## **OXFORDSHIRE COUNTY COUNCIL'S RESPONSE TO CONSULTATION ON THE FOLLOWING DEVELOPMENT PROPOSAL**

**Application no:** 21/04202/F

**Proposal:** Redevelopment for 80 retirement living apartments including communal facilities, access, car parking and landscaping.

**Location:** Former Buzz Bingo, Bolton Road, Banbury

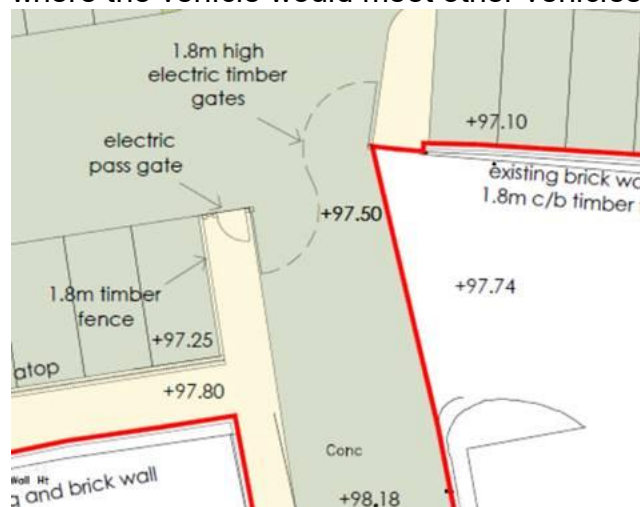
We would not recommend the carriageway be narrowed within the site especially where the vehicle would meet other vehicles as shown below.

The Refuse Strategy is not ideal as the Refuse vehicle appears to narrowly pass the parking gate entrance area, with a 10.6m long Refuse vehicle used in swept path

drawing no.536.0037.003 Rev. C. The LHA normally requires the use of 11.6m long Refuse vehicle when assessing Refuse Vehicle tracking drawings. It also not obvious from the drawing where the Refuse vehicles will park for the collection of refuse/ recyclables.
